2024-77 Access Control Upgrade at 57 N Ottawa

Addendum #1 – August 1, 2024

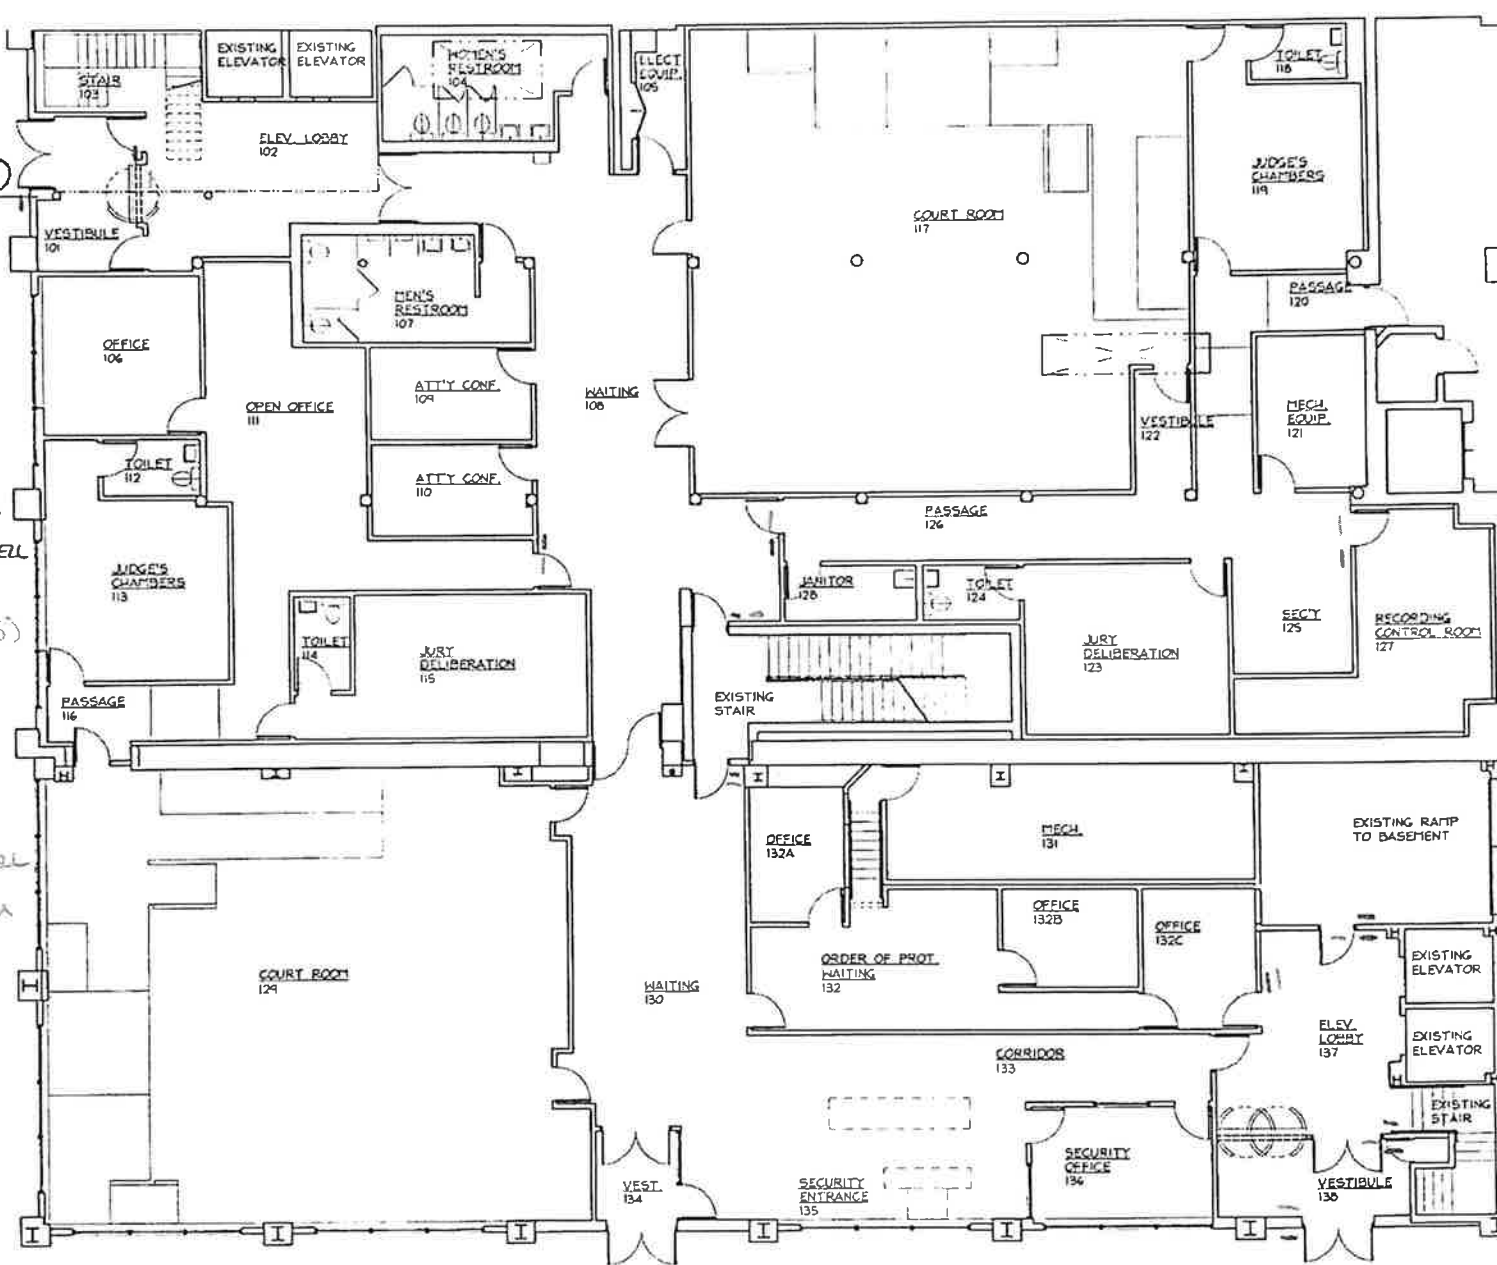
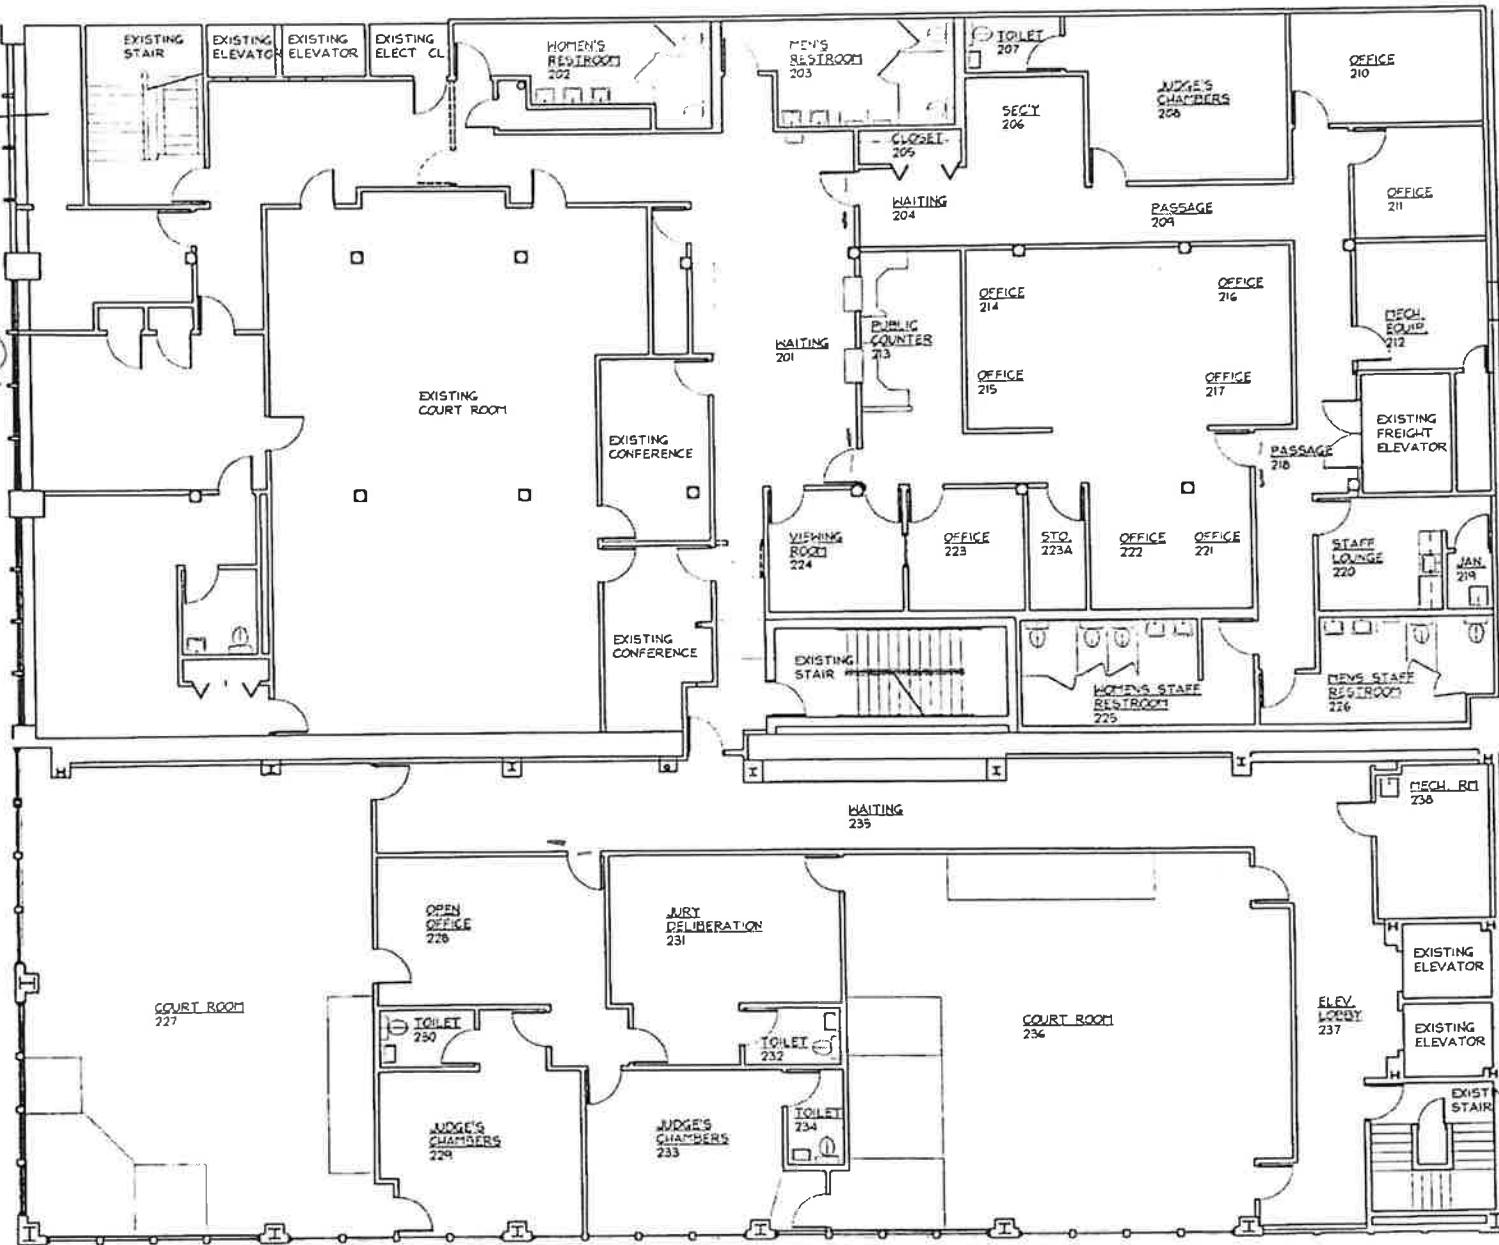
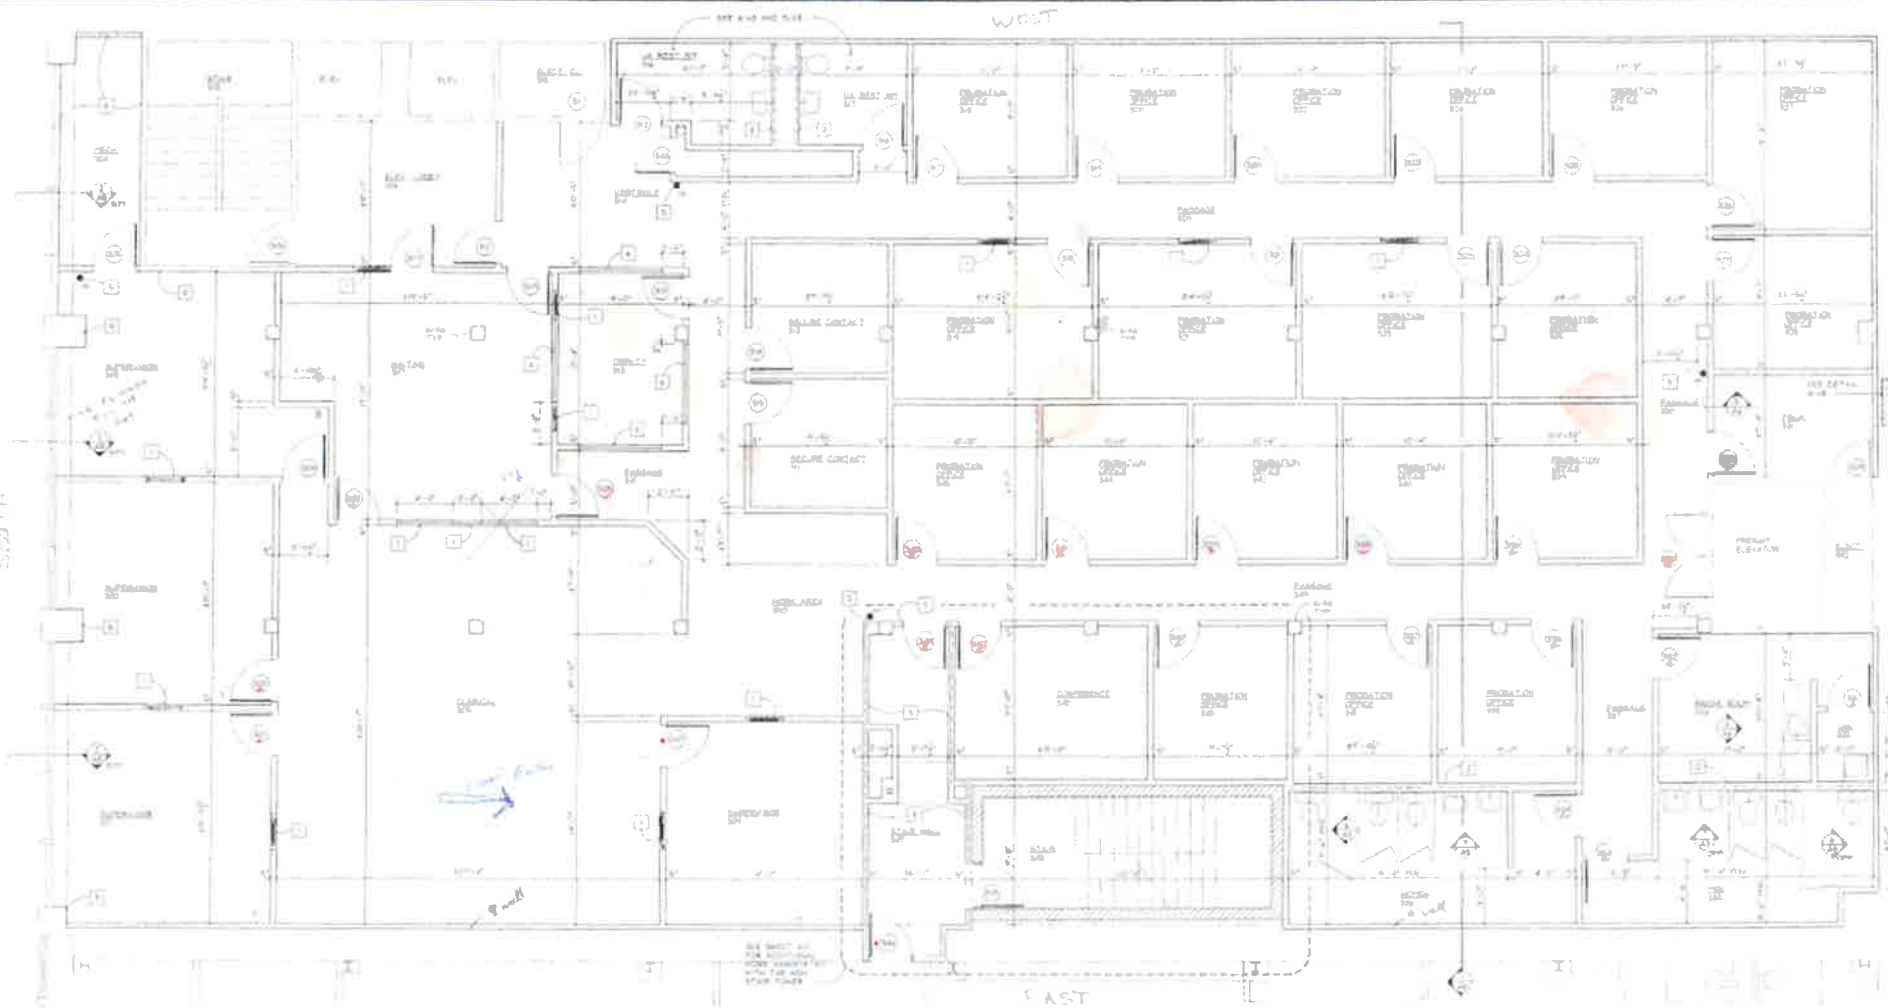
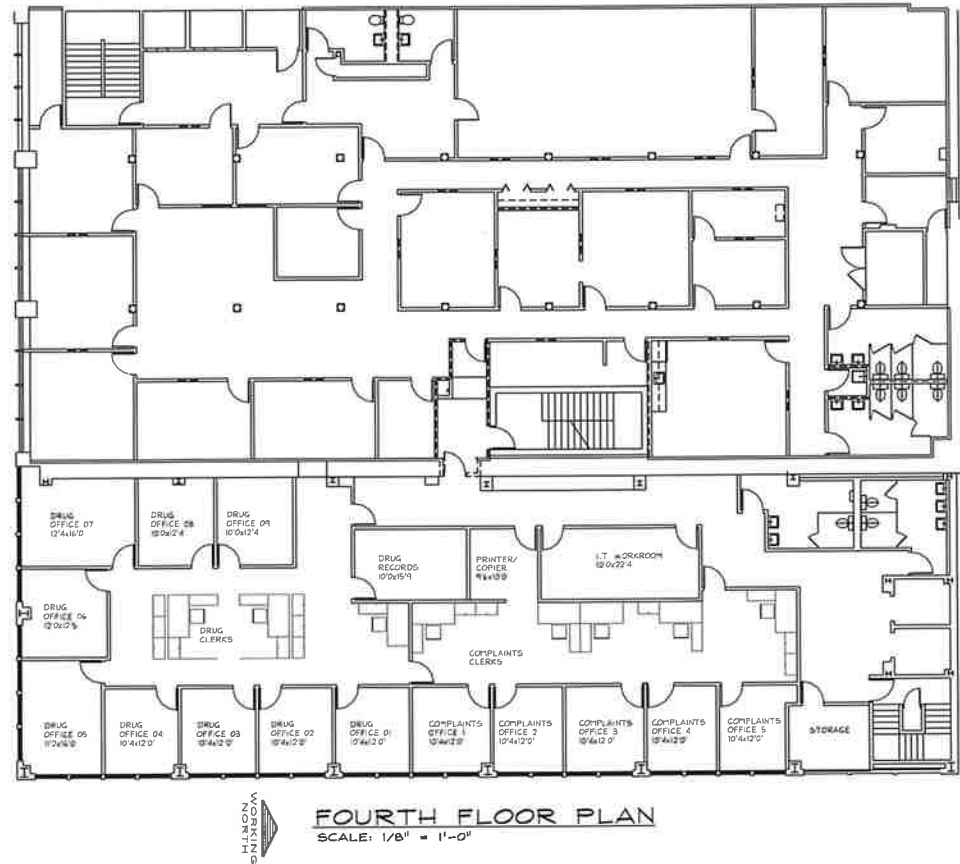
Question #2: do you have any drawings of the facility?

[Answer #2: Please see attached.](#)
